UTAH DIVISION OF OIL, GAS AND MINING

WELL NO. Federal 4076-14-23

API NO: 43-019-30474

Re: The Anschutz Corporation
Federal 4076 ~~13-23~~ 14-23
Section 23, T18S, R22E
Grand County, Utah

LOCATION LAYOUT

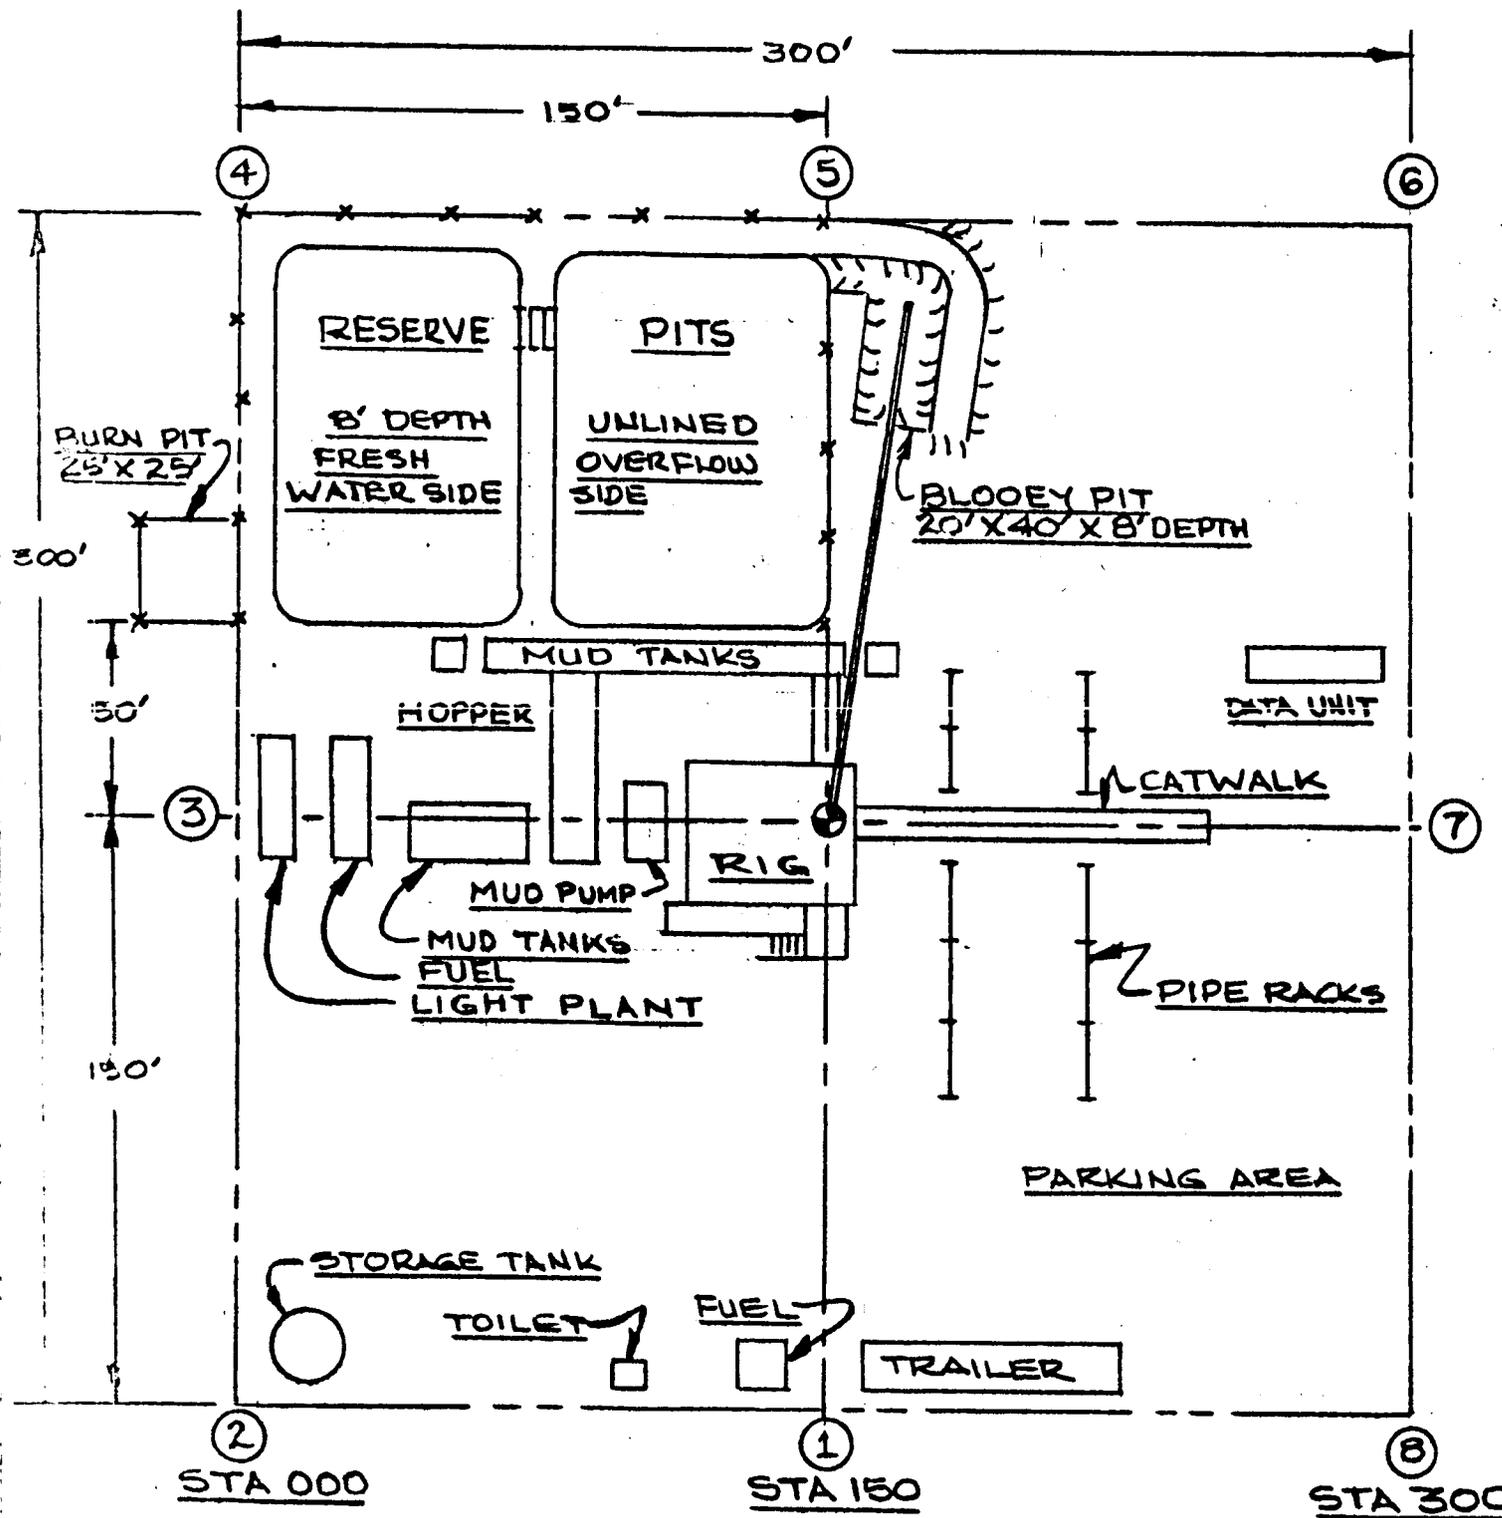
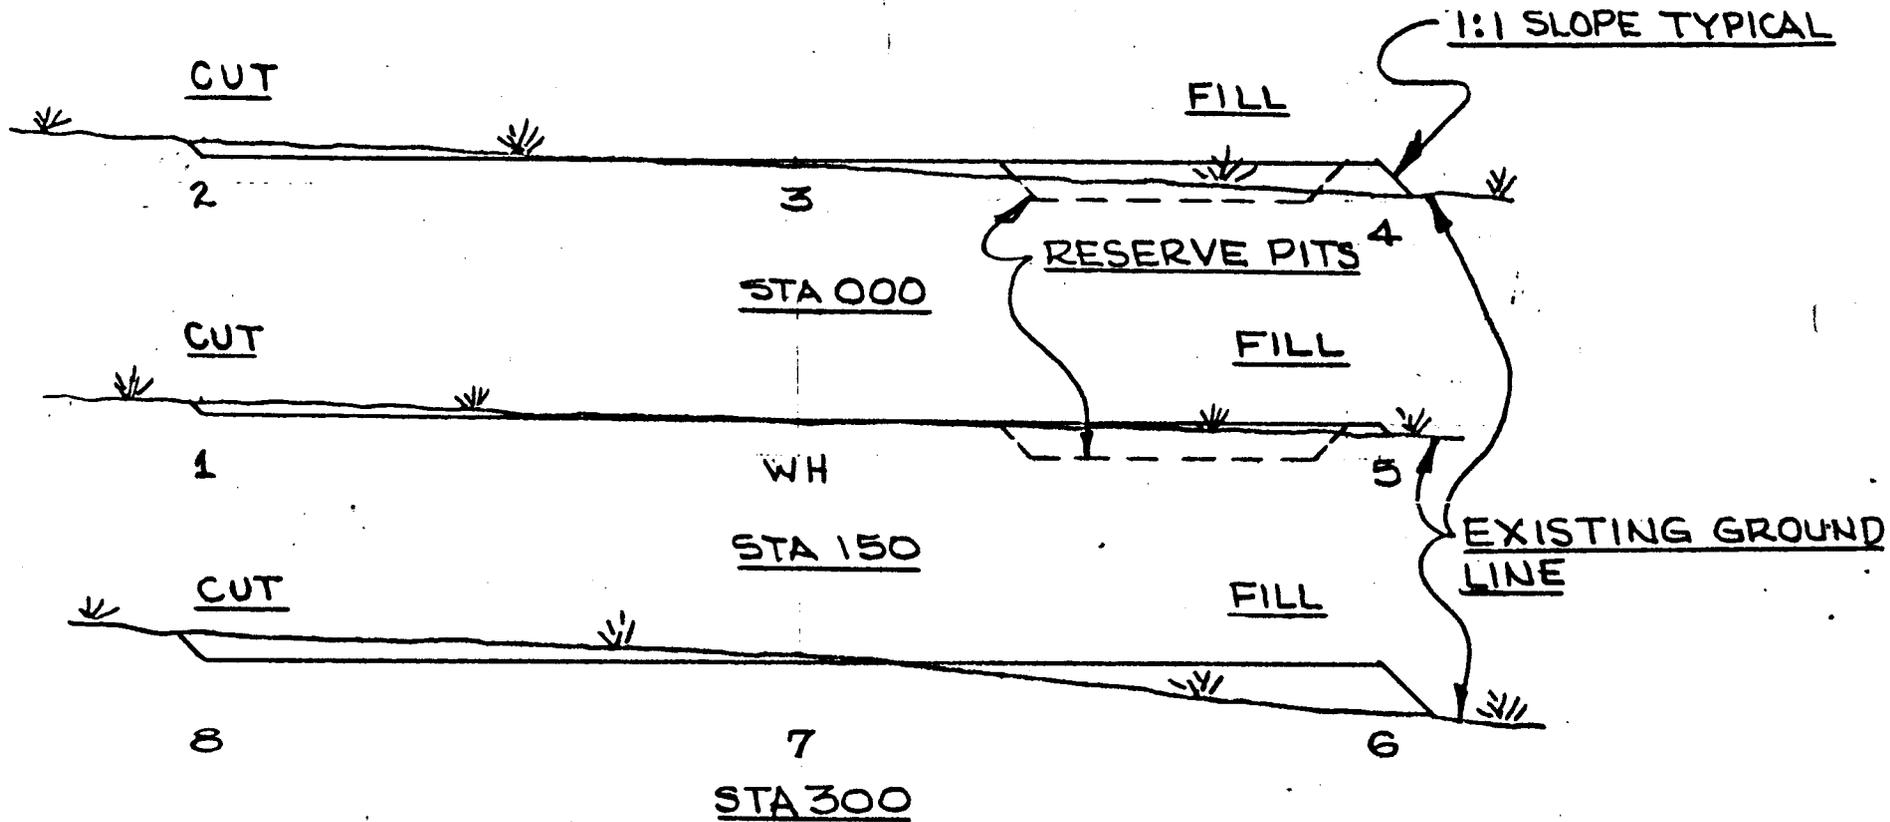
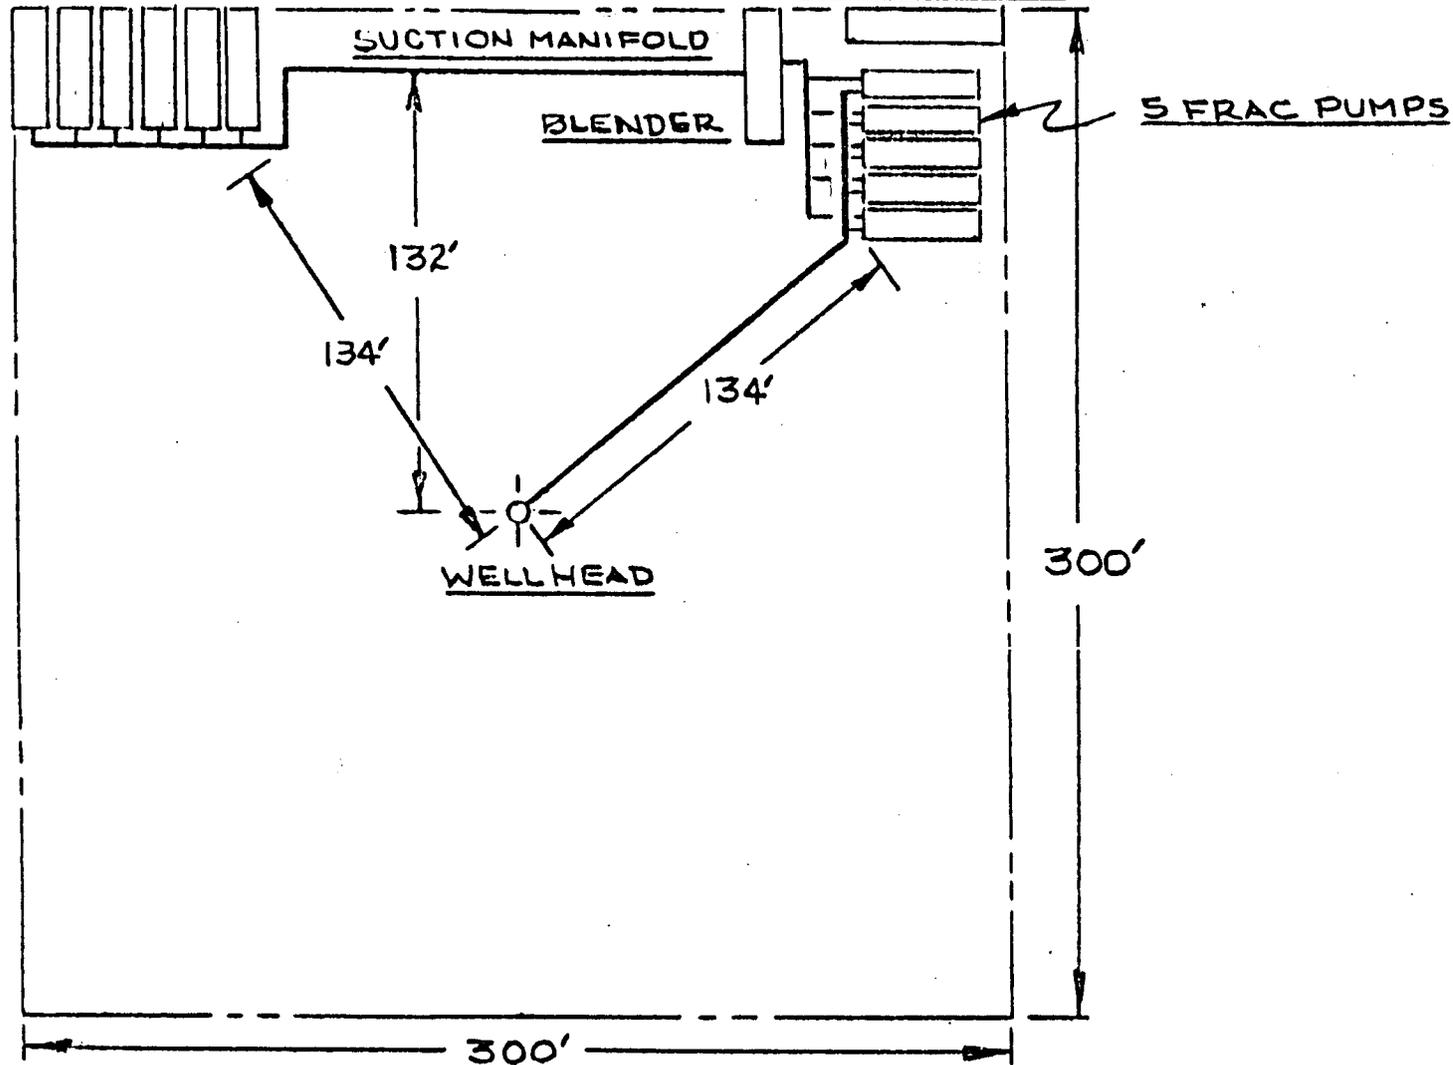
Per the request of John Evans 11-20-78, enclosed please find a corrected location layout, along with a frac diagram.

Operator indicated that he would use an emulsion type completion operations. The surface use plan did not contain a frac diagram and the operator would be required to supplement his surface use plan. A new Drill Rig Layout plan is required as an air drilling rig would be used. A blooie pit would be required. No Production Facility Layout supplied - Operator said he could not provide this data at this time.

The operator is to provide USGS and BLM with a new Drill Rig Layout and Drill Pad Diagram prior to approval. Production facilities are not approved. The operator proposes emulsion type frac and the frac diagram would be required with a Sundry Notice for approval. The access road requires extensive upgrading to control erosion per BLM specifications. (See field copy of A.P.D. for recommended changes) Surface use plan not signed. (Signed copy in file)
